STAFF RECOMMENDATION

NCPC File No. 6903

FORT BELVOIR
BRAC 133 PROJECT, MARK CENTER DEVELOPMENT
(WASHINGTON HEADQUARTERS SERVICES)

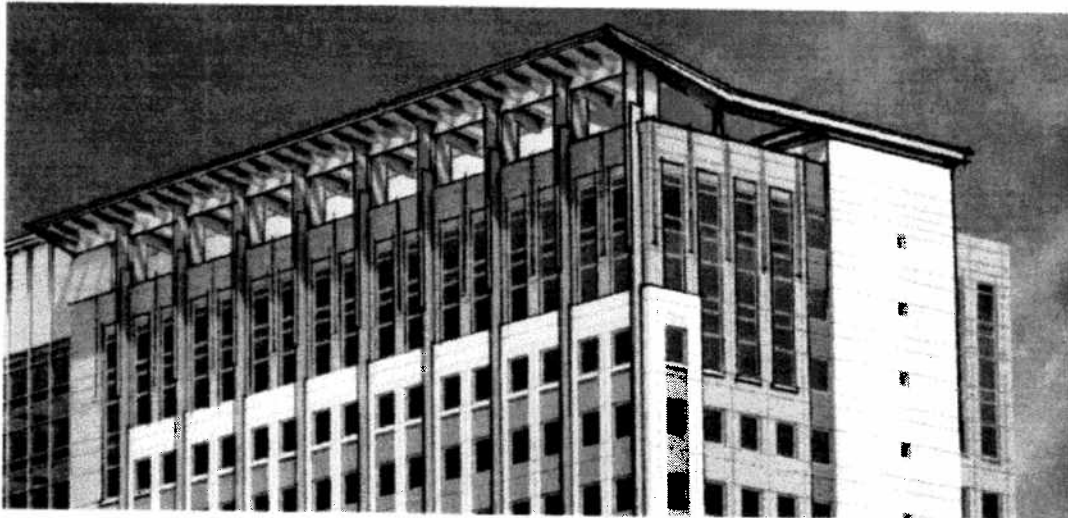
The two building drawings in this letter reflect new drawings by the applicant's architect after receiving City comments, and as a result, have begun to reflect City staff design comments and concerns.

We recommend the use of additional glass (some of which will not be vision glass because of the blast protection requirements) to reduce the perceived size of the building, provide additional visual variety and provide a more clearly defined base, middle and top to the building. We also recommend the use of contrasting darker and lighter colors of architectural precast panels to enhance vertical expression and multiple rhythms.

One of the design challenges inherent in the proposal is the required blast resistant facade. This initially resulted in a predominantly solid faced expression with square windows, making the building appear larger and the windows smaller than required by the City's design guidelines. The smaller windows were atypical of most office buildings and made the building appear more monolithic. In response to the City's comments the windows in the revised design were enlarged for the entire building and darker spandrel panels were added, resulting in an overall less monolithic expression.

As a way to better define the top of the building and to balance the solid to void ratio, the applicant has agreed to introduce a three story glass expression around the top of the building. The added glass feature creates a clearly defined frieze band and top expression and reduces the perceived mass of the building.
